Service Bulletin

Bulletin No.: PIT6396A

Subject: SES MIL with DTC P2535 / P12A6 / P10DA / C111B / P157A After Fuel Pump Driver Module Replacement 13565642

6954816

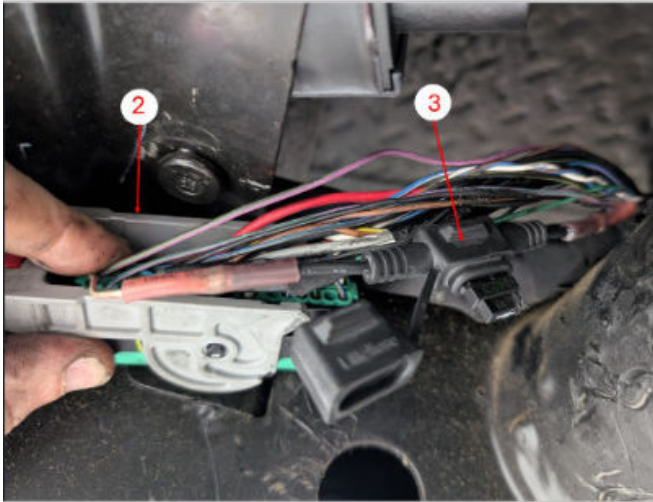
Engineering is working on design improvements for a new fuel pump driver module. In the meantime, a diode can be installed in line with the water-in-fuel sensor circuit 6862, shown below (1), to correct the issue.

1. Locate either the K111 fuel pump driver module connector terminal 1 OR the E11A Fuel Heater/Water In Fuel sensor connector terminal 3, whichever is the most convenient to install a mini inline fuse holder. Next, cut circuit 6862 a few inches from the connector. Then connect a mini fuse holder, see parts sections for details, in line with circuit 6862 using two salmon splice sleeves, as shown below (3). In the example below, the repair is being done at the K111 fuel pump driver module (2) end, but it could be done at the E11A Fuel Heater/Water In Fuel Sensor connector end, whichever is most convenient.

2. Install a fuse style diode, GM P/N 12135037, into the mini inline fuse holder so the arrow on the diode is pointing towards the E11A Fuel Heater/Water In Fuel Sensor, as shown above (1).
